X3T13/D96104r9

29 October 1996

ATA Overlap Proposal

This document presents the detailed text changes to the ATA-3 document (X3T10/2008Dr6) for the Overlap proposal. It is based on the Overlap proposal submitted by Western Digital Corporation (X3T10/95-258r0) with the changes presented by Quantum Corporation (X3T10/95-257r0).

Figure nn describes the execution of a READ DMA O/Q or WRITE DMA O/Q command.

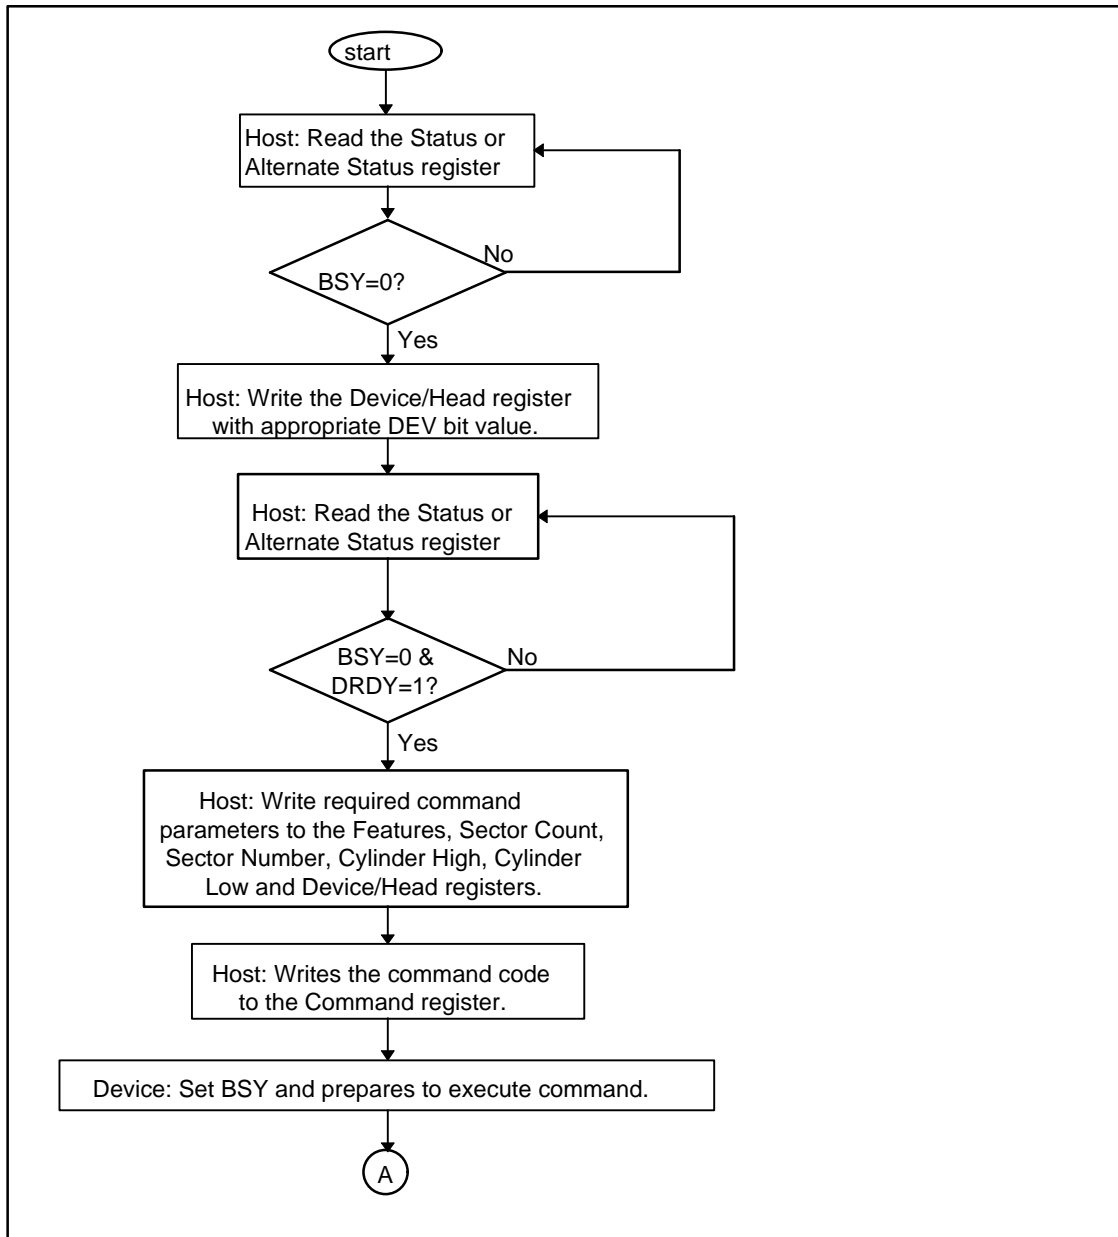
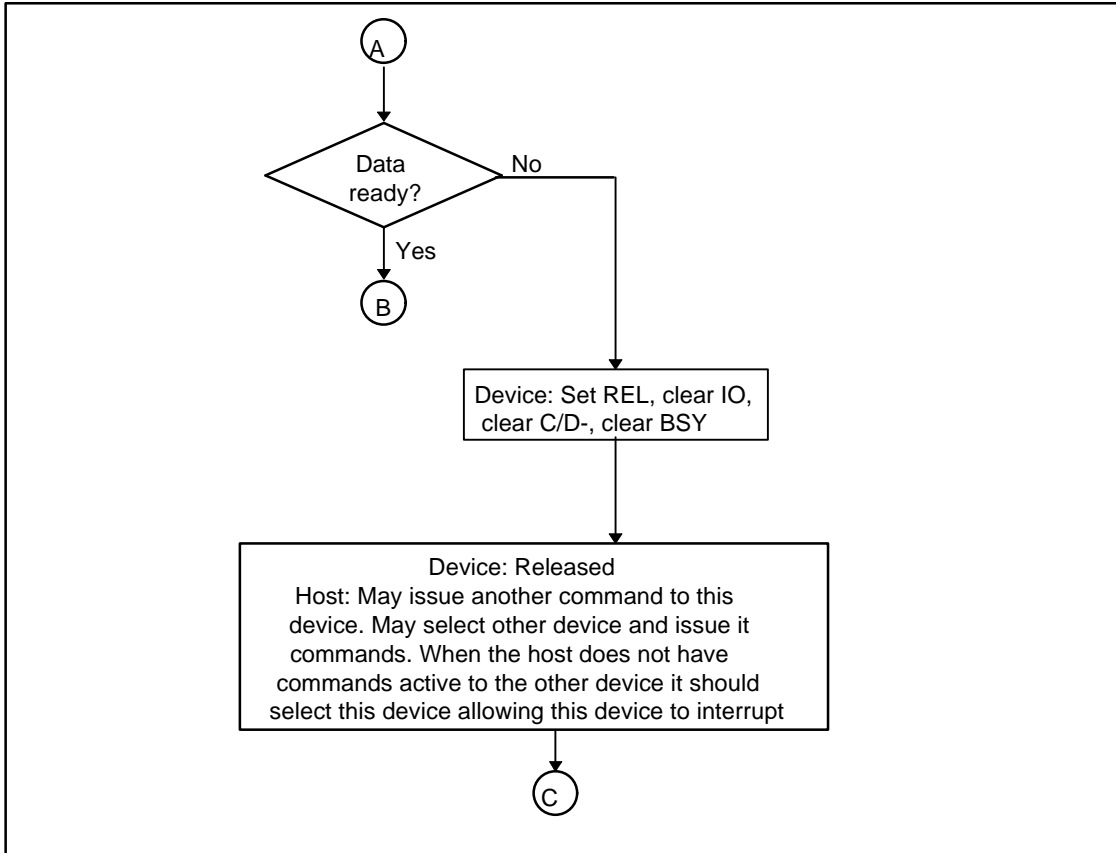
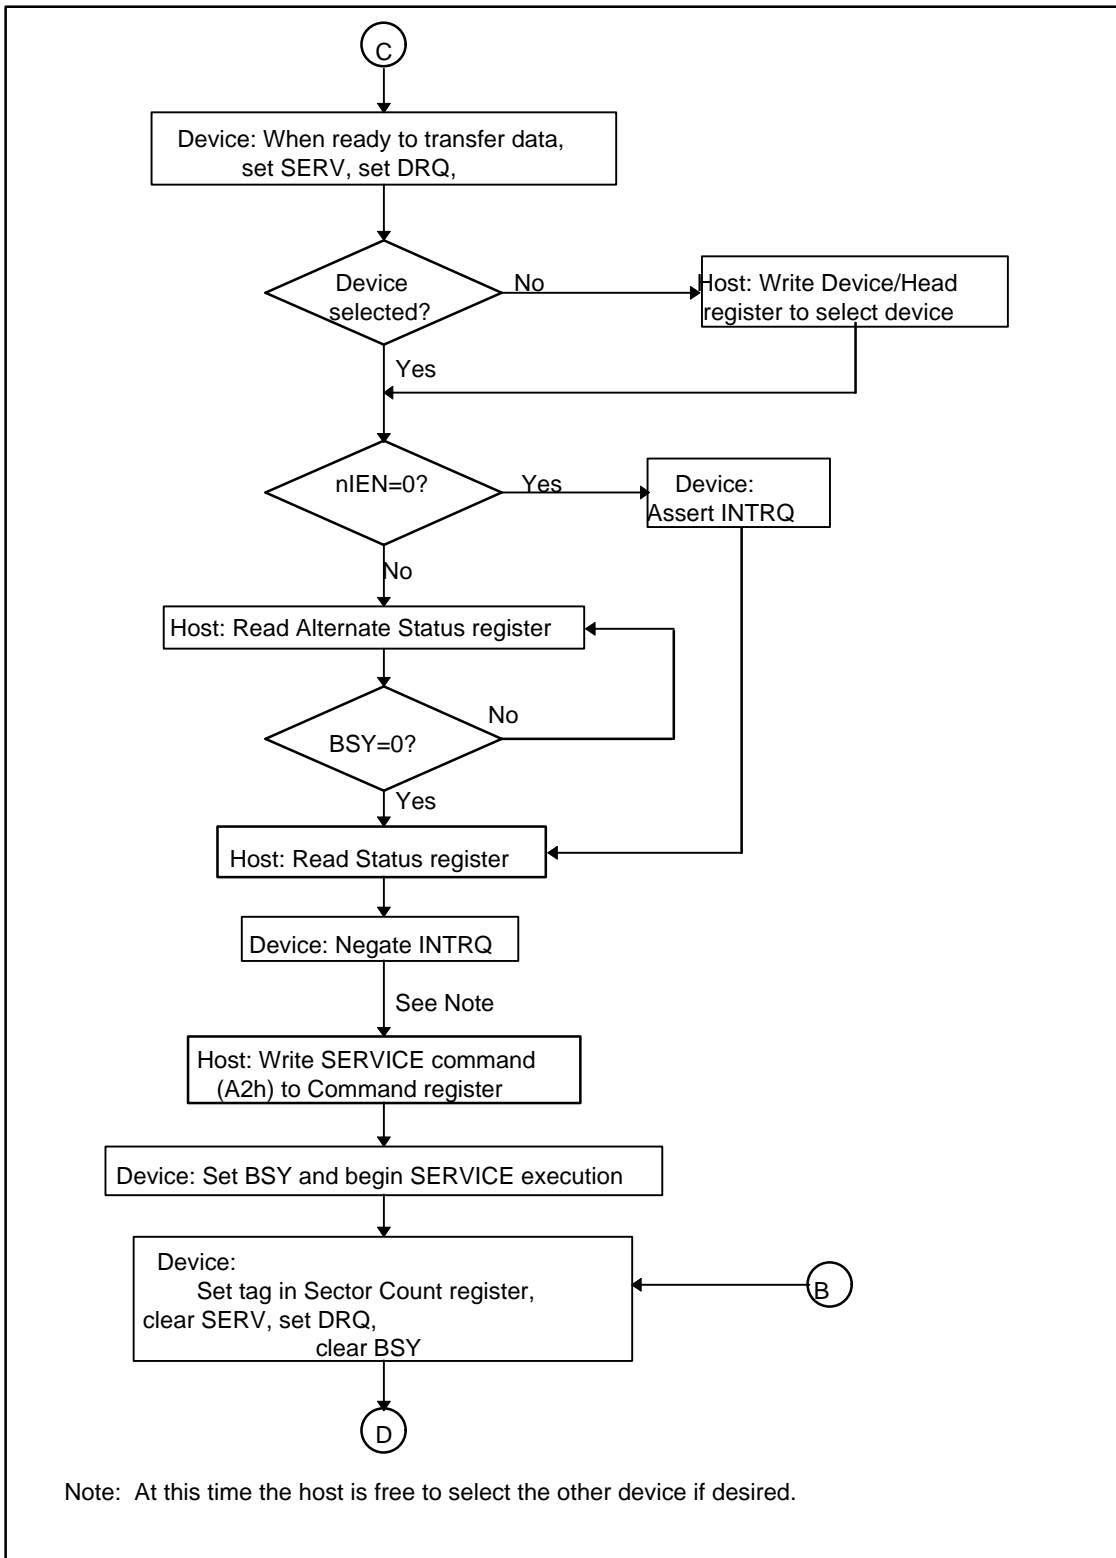
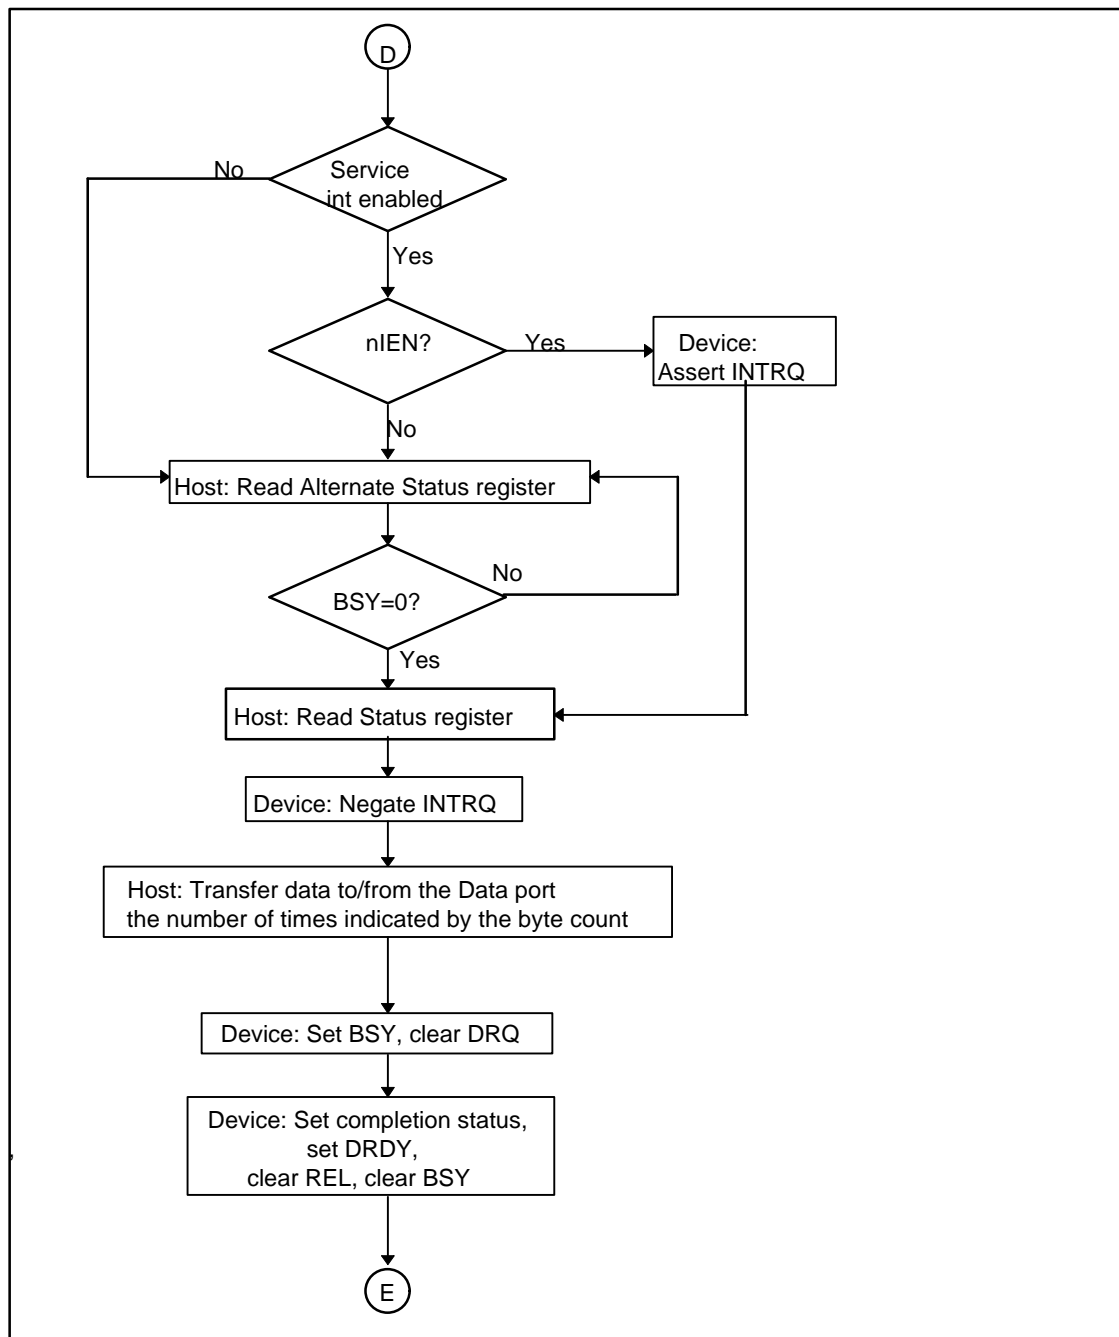
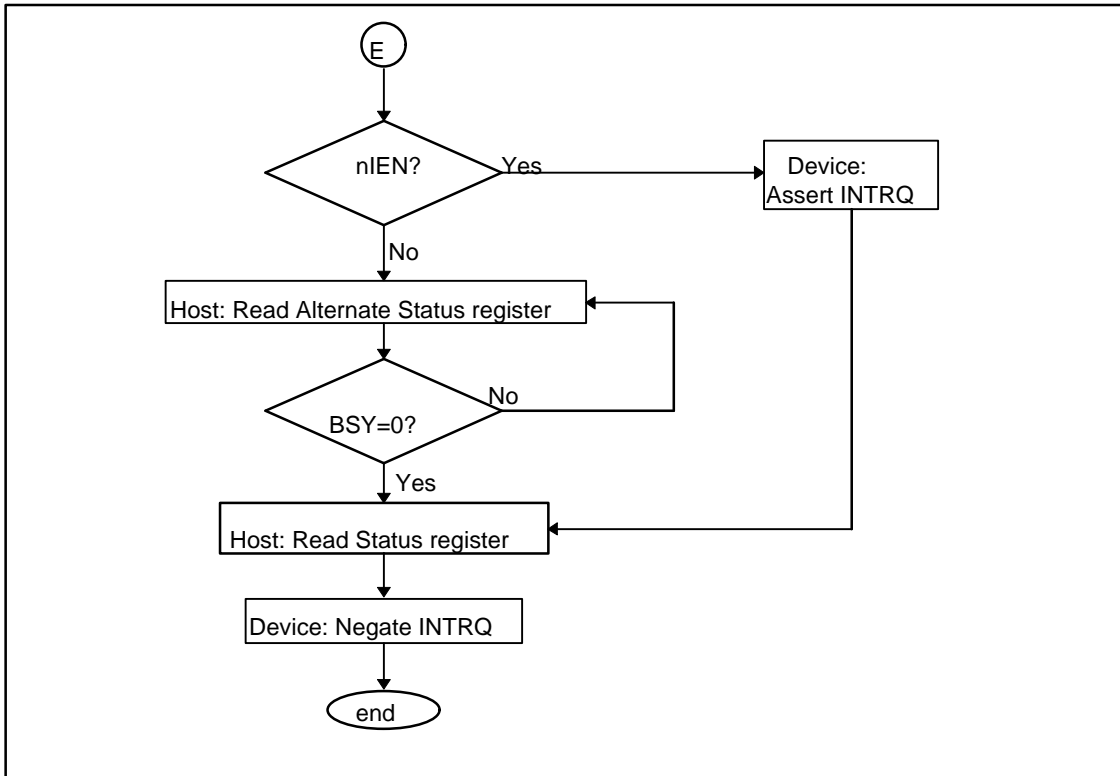
8.* READ/WRITE DMA O/Q command protocol

- READ DMA O/Q
- SERVICE
- WRITE DMA O/Q
